City of Bristol
Conservation Commission/ Inland Wetlands and Watercourses Agency

SPECIAL MEETING - WEDNESDAY, MAY 22, 2024
CITY HALL COUNCIL CHAMBERS
111 NORTH MAIN STREET
7:00 P.M.

- b. Application #2020 – Wetlands application for the restoration of the White Bridge Waterworks facility at Maltby Street; Assessor's Map 52 & 53, Lots 11, 15, 16B16A, 17, 145, 147, 149, 150 & 151; New Britain Water Department, Ramon Esponda, Deputy Director, applicant (Public Hearing Closed at May 6, 2024 Regular Meeting).

**BRISTOL CONSERVATION COMMISSION
INLAND WETLANDS AGENCY
FORM IW-2 (Application for a Wetlands Boundary Change)**

4. Drawing: C-23

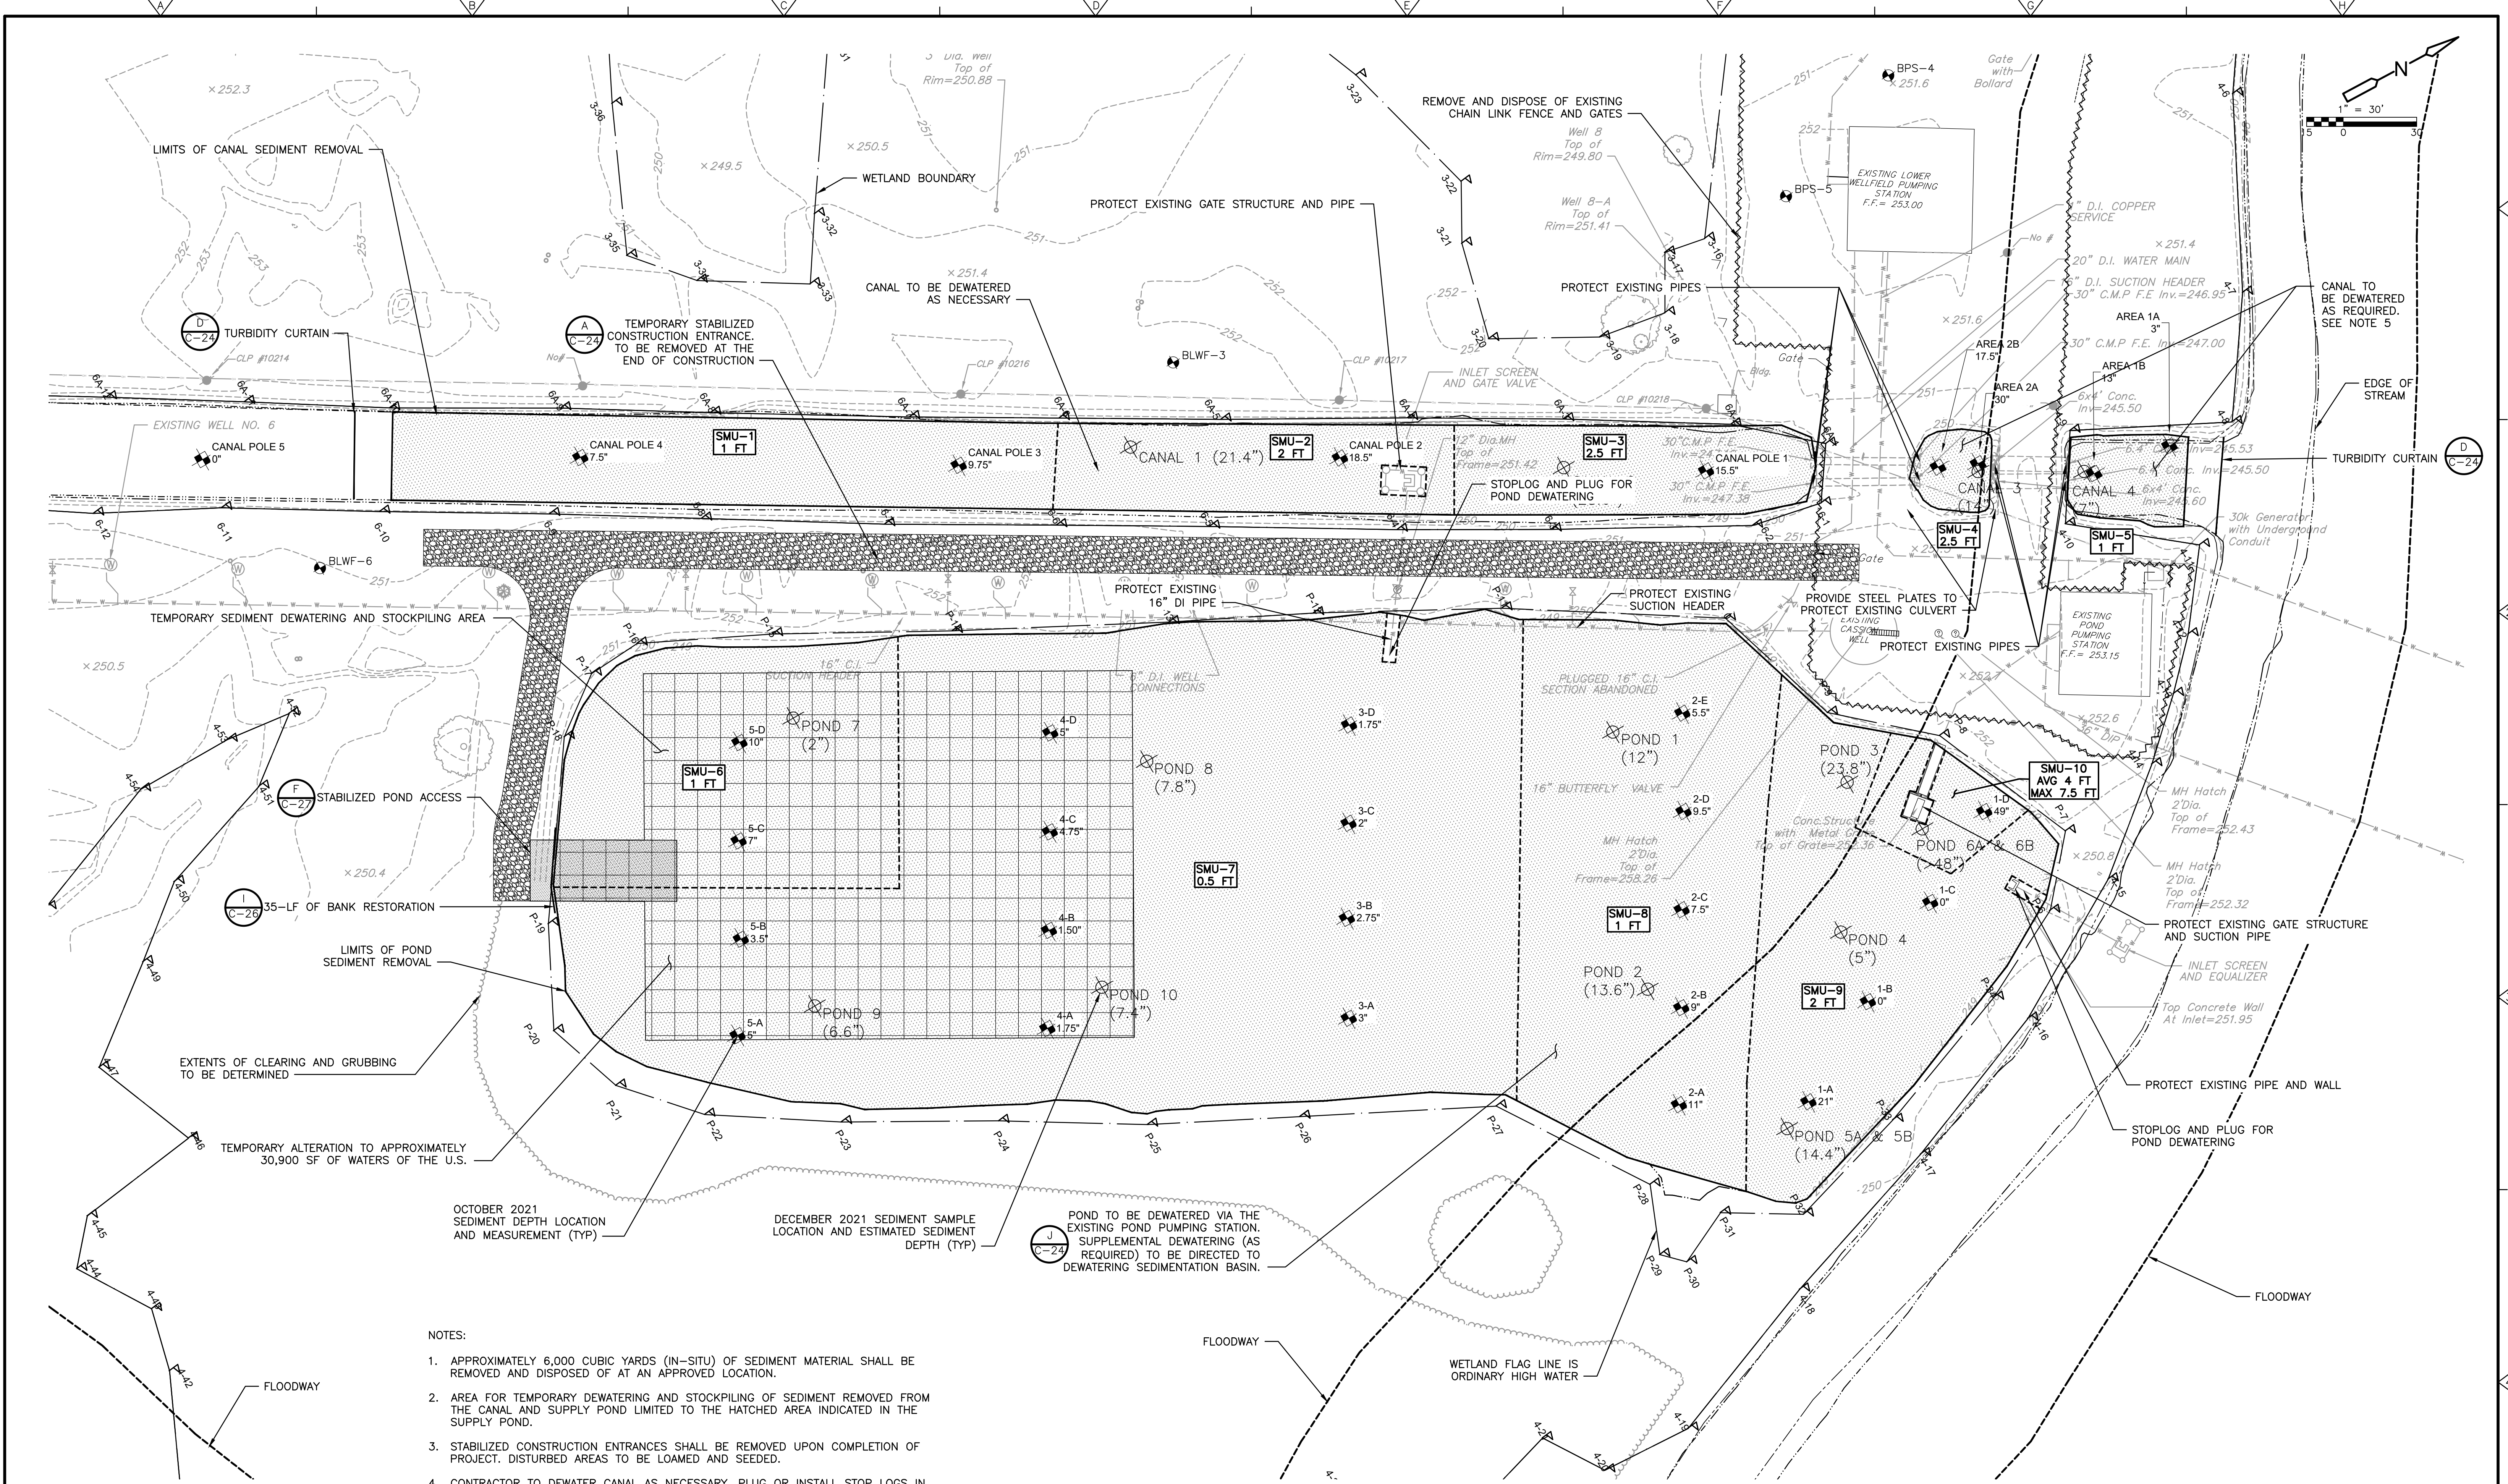
Response #4. Floating turbidity curtains are to be located within the canal, east and west of the proposed sediment removal areas. See revised Sheet C-23 in **Attachment 4.**

4/22/24 Applicant Response: Floating turbidity curtains are to be located within the canal, east and west of the proposed sediment removal areas. See revised Sheet C-23 in Attachment 4.

A1-1
SHEET WR-1
SCALE: 1' = 10'

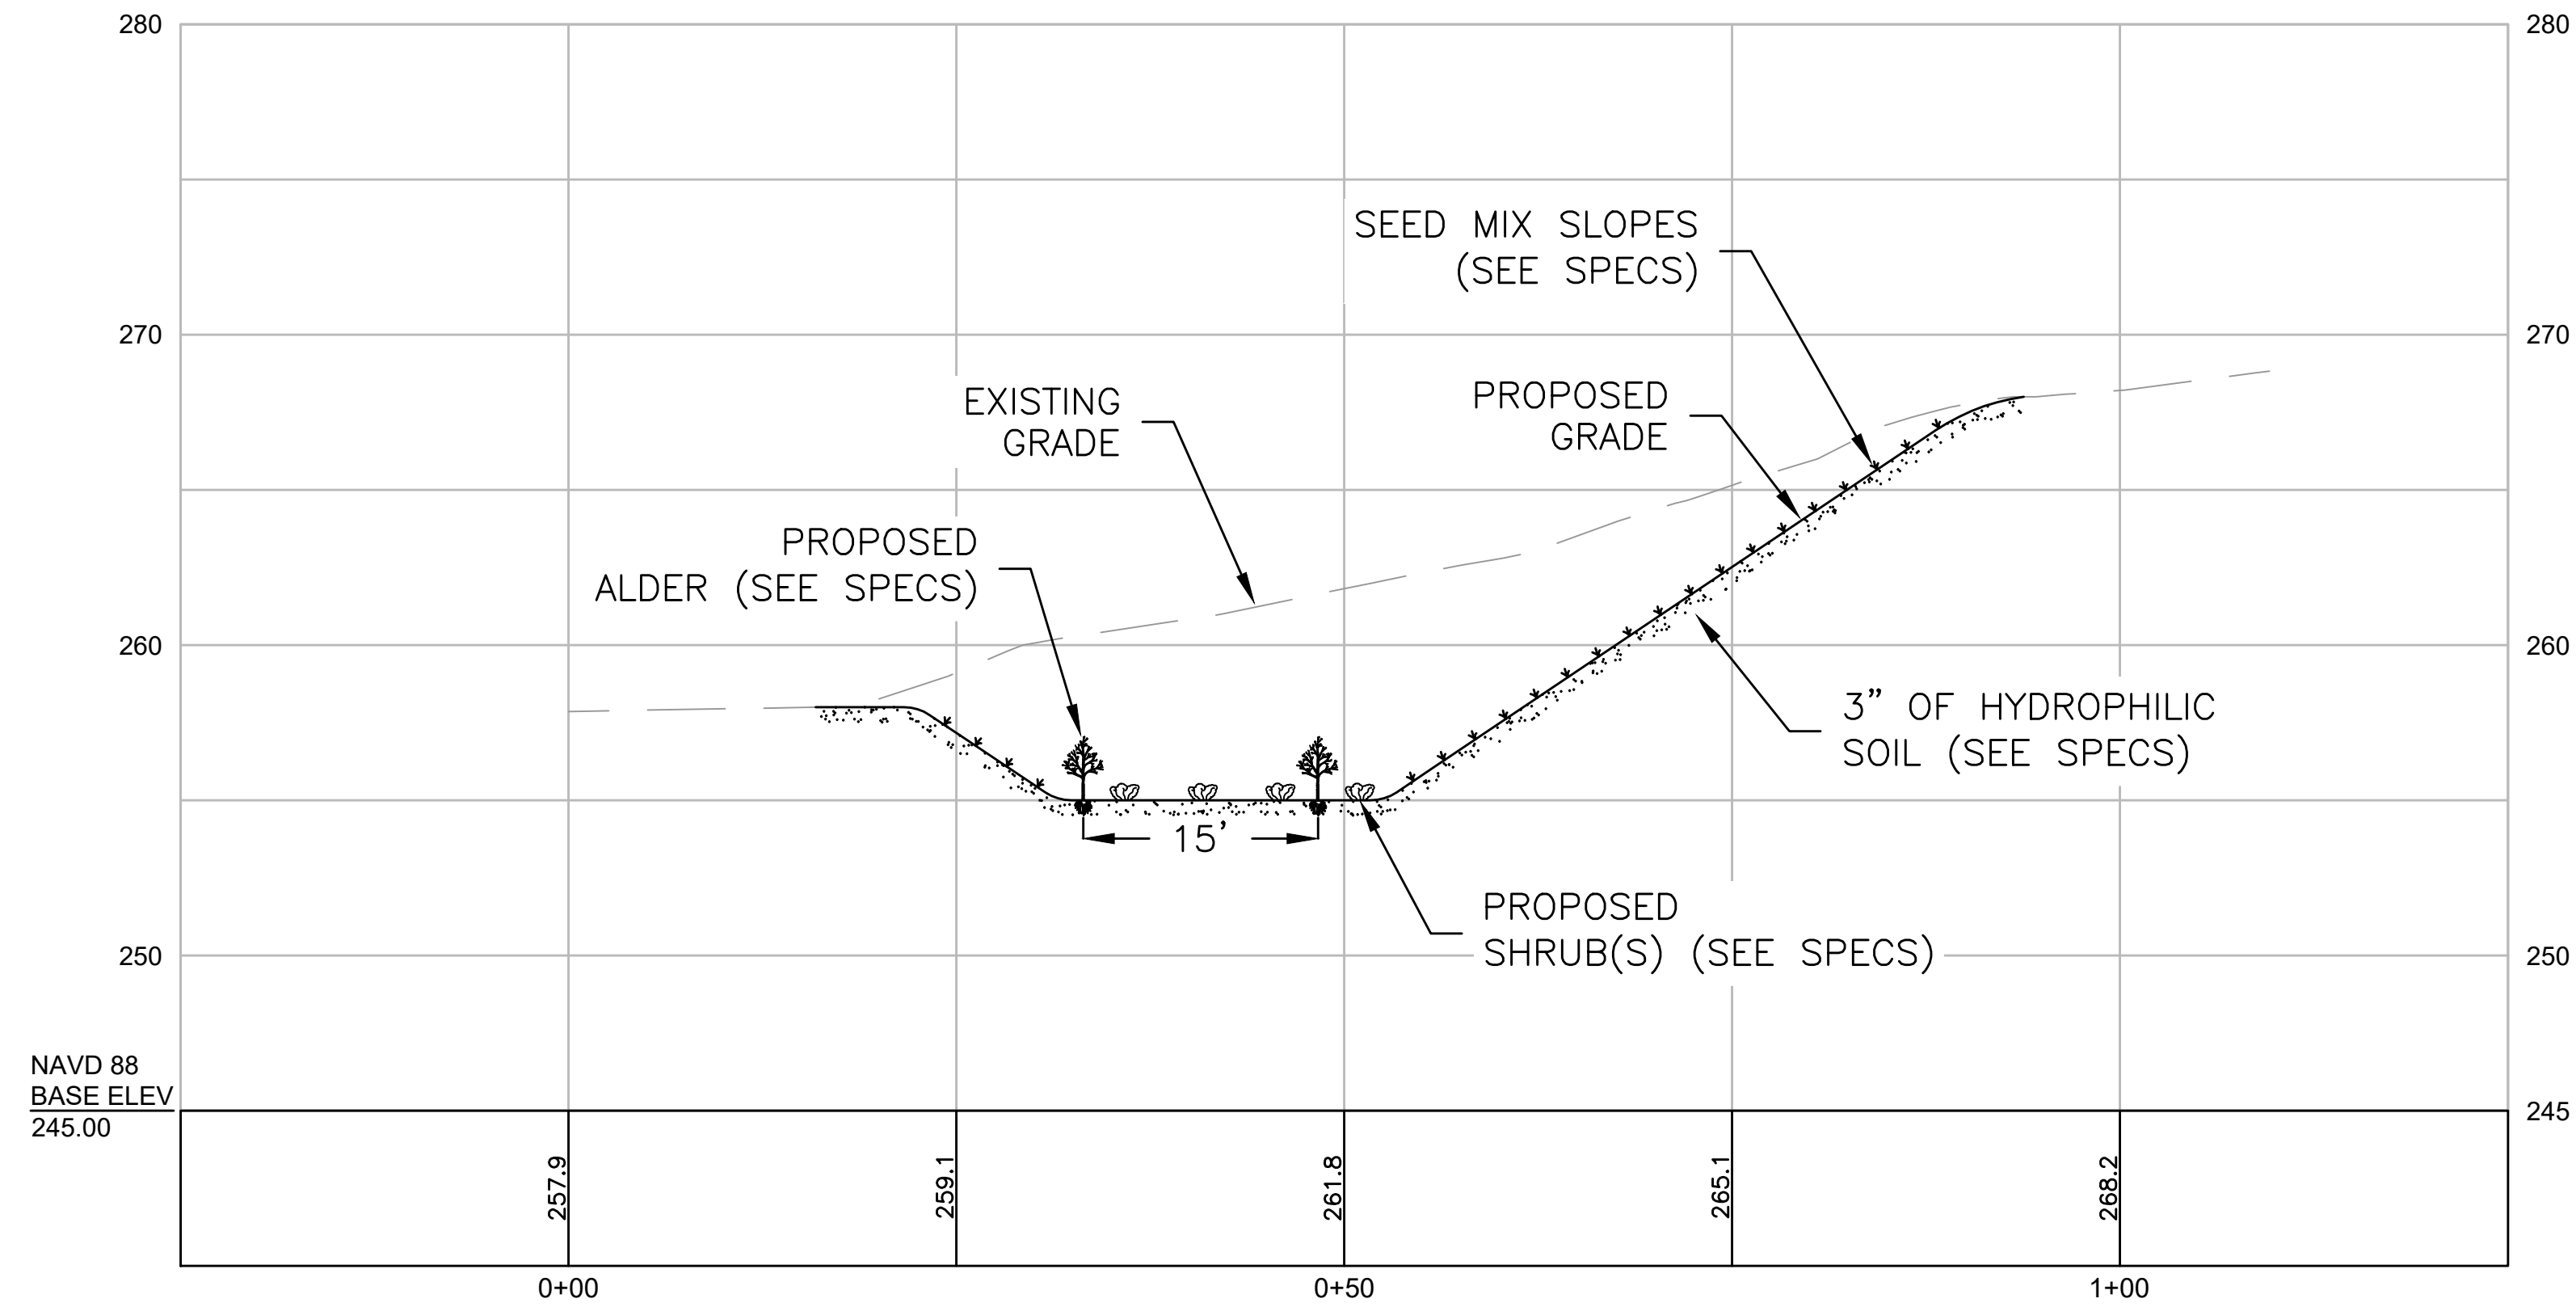
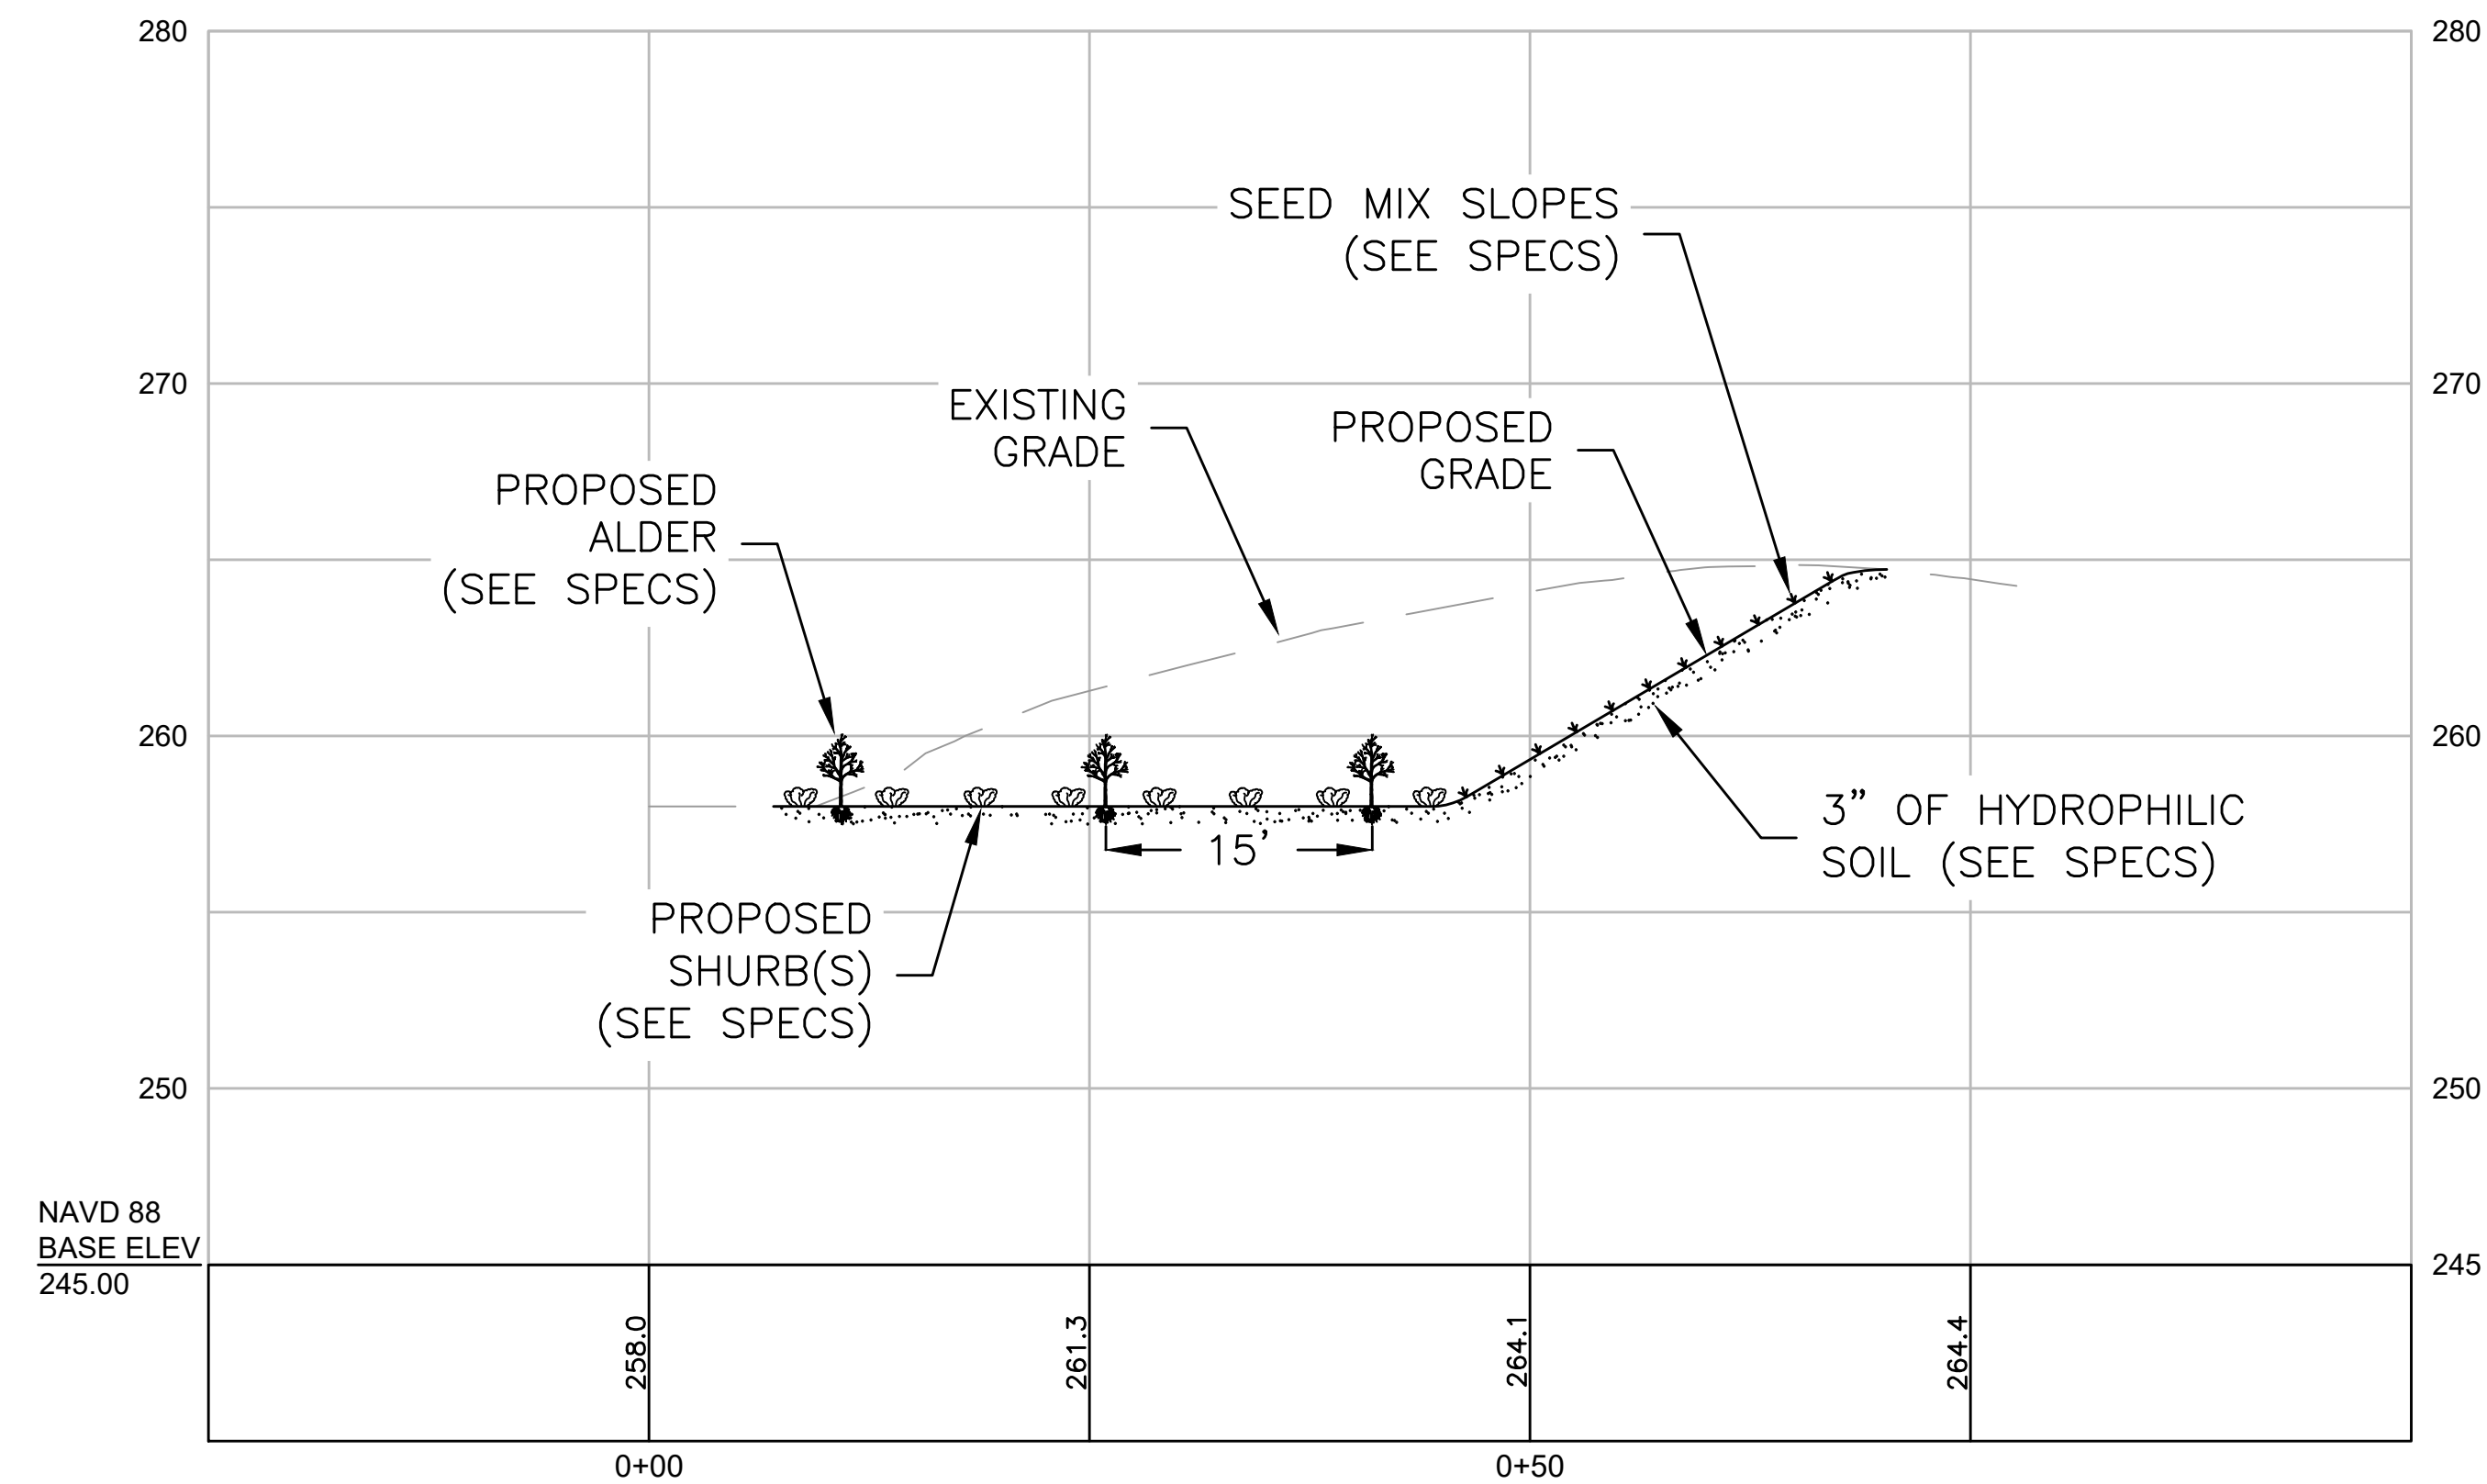
2. Regarding the revised wetland mitigation / floodplain compensation areas:
 - a. Sheet WR-1 shows a wetland replication area (represented by section A1-1) to excavate up to 8' in depth from an area of approximately 28,726 SF in size (to el 261). This area is located immediately adjacent to brook. The proposed transition slope areas to the north and west of this area add additional significant area of
